**Notice of Allowability**

10/688,534

YONG ET AL.

FIG. 12

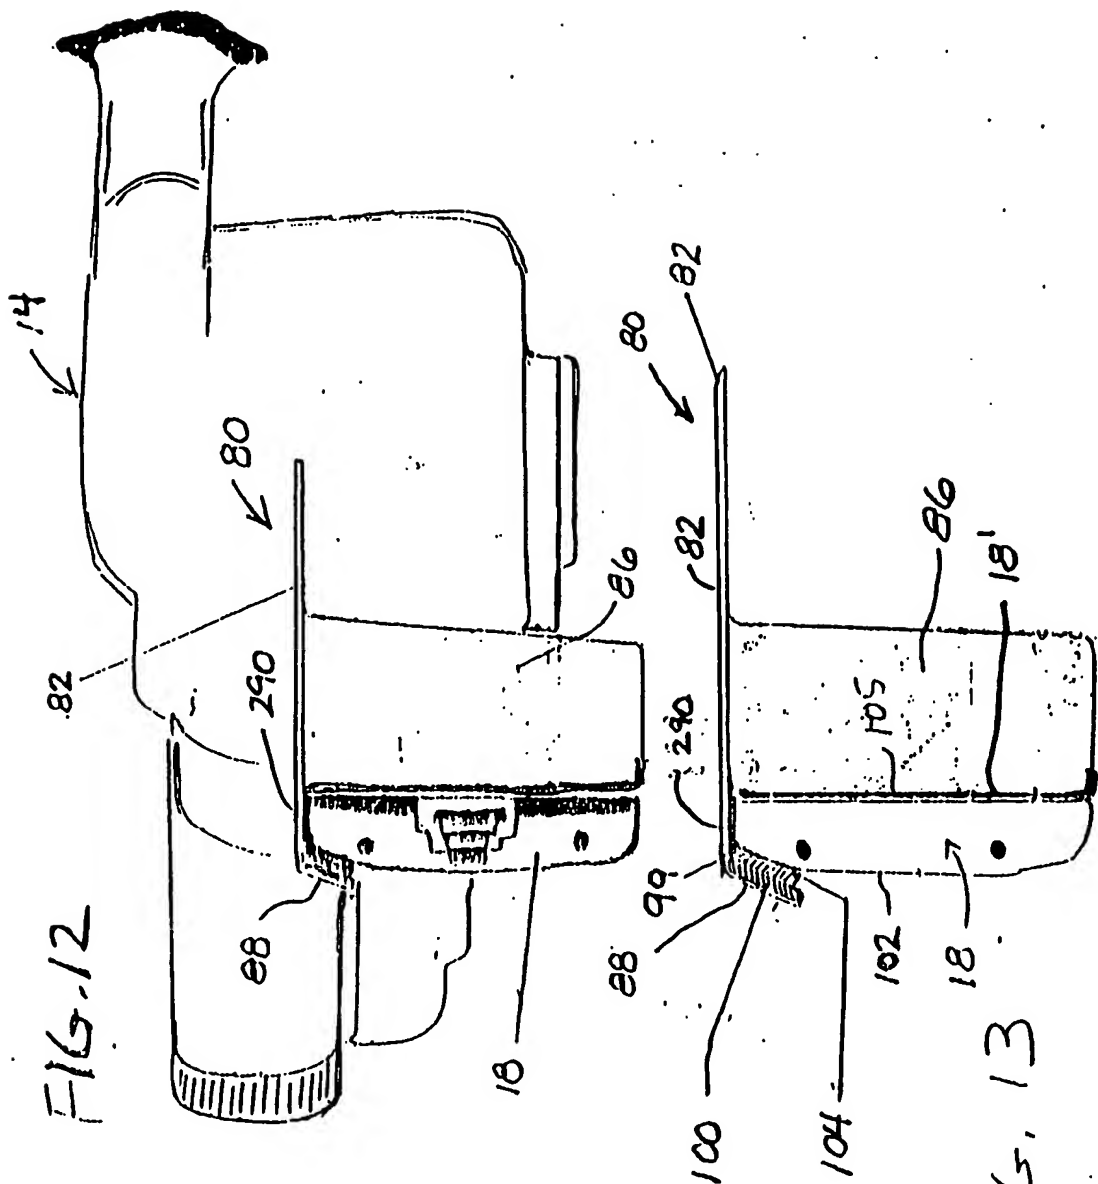
Figures 1-20- Lines, numbers, and letters are not uniformly thick and well defined, clean, durable, and black (poor line quality). See 37 CFR 1.84(i).

Corrected drawing sheets in compliance with 37 CFR 1.121(d) are required in reply to the Office action to avoid abandonment of the application. Any amended replacement drawing sheet should include all of the figures appearing on the immediate prior version of the sheet, even if only one figure is being amended. The figure or figure number of an amended drawing should not be labeled as "amended." If a drawing figure is to be canceled, the appropriate figure must be removed from the replacement sheet, and where necessary, the remaining figures must be renumbered and appropriate changes made to the brief description of the several views of the drawings for consistency. Additional replacement sheets may be necessary to show the renumbering of the remaining figures. Each drawing sheet submitted after the filing date of an application must be labeled in the top margin as either "Replacement Sheet" or "New Sheet" pursuant to 37 CFR 1.121(d).
